**DUNAY  
MISKEL  
BACKMAN** LLP

**Subject:** Soleste Pompano Beach  
**Development Review Committee Comment Responses**  
**Case No:** 21-12000041  
**RESPONSE DATE:** March 17, 2022

#### BUILDING TYPOLOGY AND PLACEMENT REGULATING DIAGRAM:

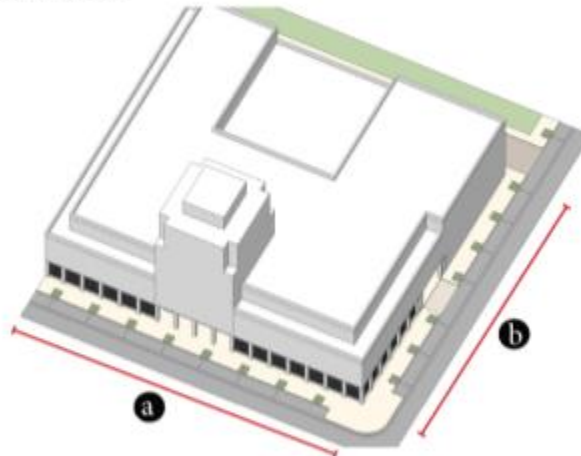
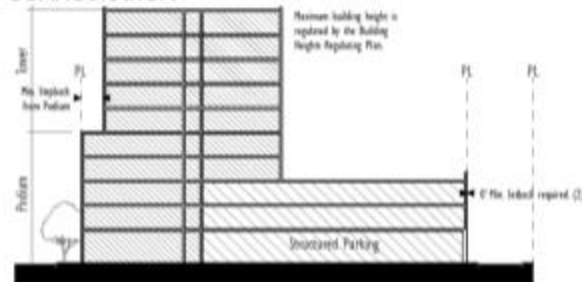
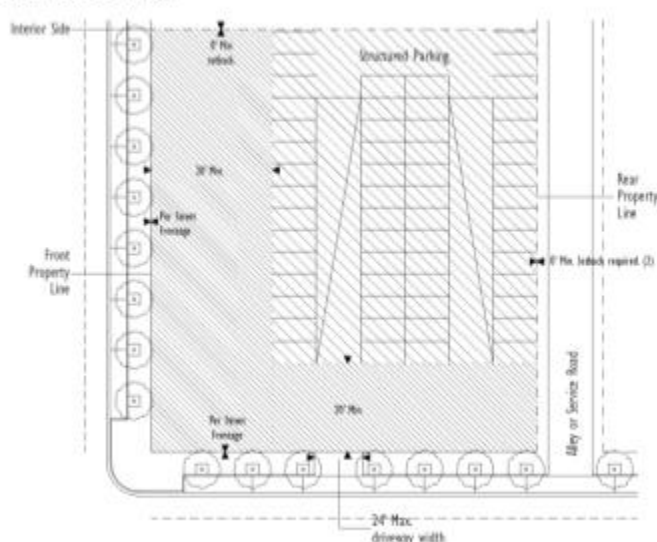
**Response: Noted. Refer to sheet A-3.1 & A-3.2 Building Elevations.**
14. Identify the Building Typology that is proposed, in accordance with the Building Typology and Placement Regulating Diagrams and Dimensional Standards of the TO.

Response: Refer to Zoning Legend on Sheet A-1.2 Zoning Data. The zoning classification is TO-EOD. The Building Typology is Tower Building type as per diagram below.
